Engineering Change Order

ECO-040704

Product Line:	HW-AFX-SP3-400
Product Revision:	Rev 2
ECO:	040704
Effective Date:	04/07/04
Initiator:	Bill Pratt

Figure 1.

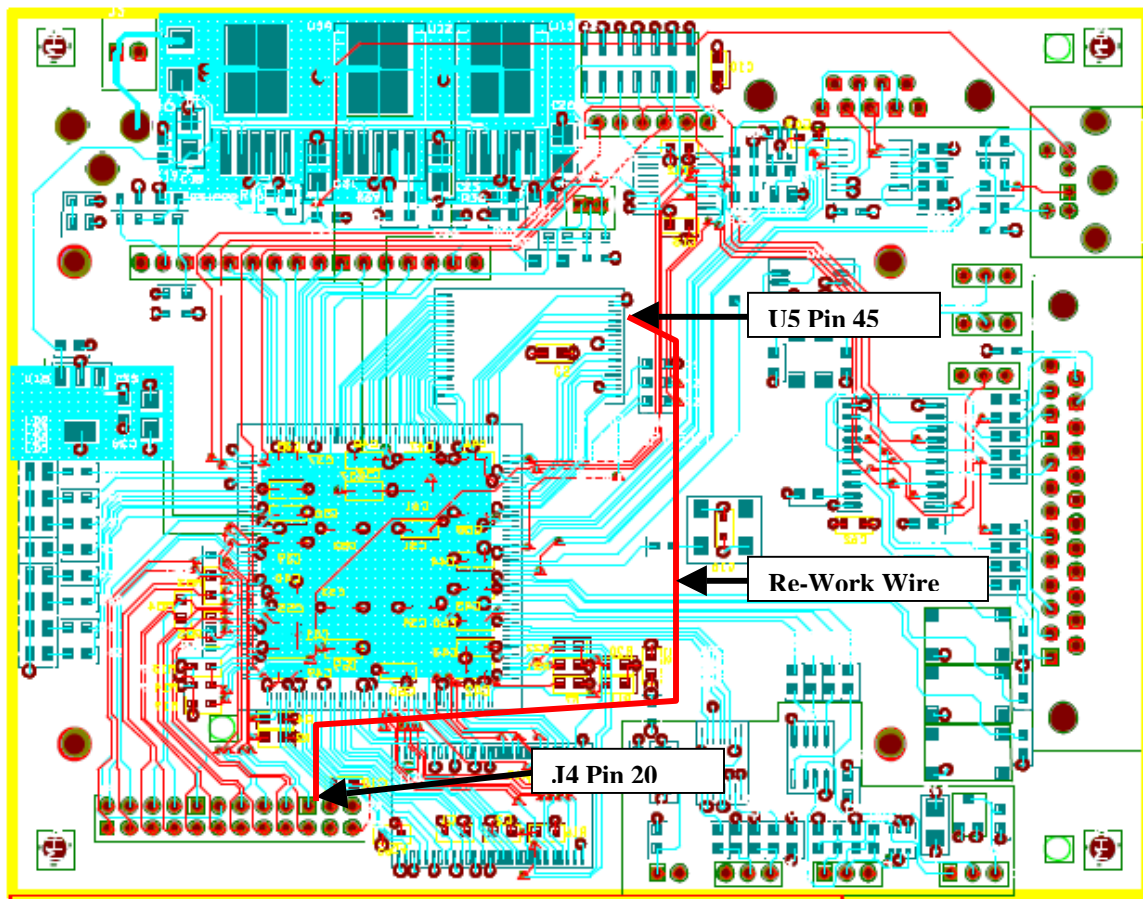
The HW-AFX-SP3-400 development board has a missed route between the M29W320DB (U5) Flash, Pin 45 and the XC3S400 (U1) FPGA.

U5 is implemented with a byte wide data interface, the byte wide configuration requires DQ15A-1 pin 45 of U5 to behave as an address pin when in byte wide mode. DQ15A-1 low will select the LSB of the word; on the other addresses DQ15A-1 high will select the MSB.

U5 is not addressable unless a jumper wire change is implemented on the HW-AFX-SP3-400 board.

Installation of a jumper wire is required for correction:

Install a jumper wire from U5 Pin 45 (DQ15A-1) to J4 Expansion Connector (Header 12X2) Pin 20 (FPGA I/O 16).

U5 Pin 45 (DQ15A-1) will be routed to the XC3S400 (U1) Pin 175, allowing proper interface to the M29W320DB Flash (U5) in byte wide mode.

Please refer to Figure 1. for detailed jumper installation.
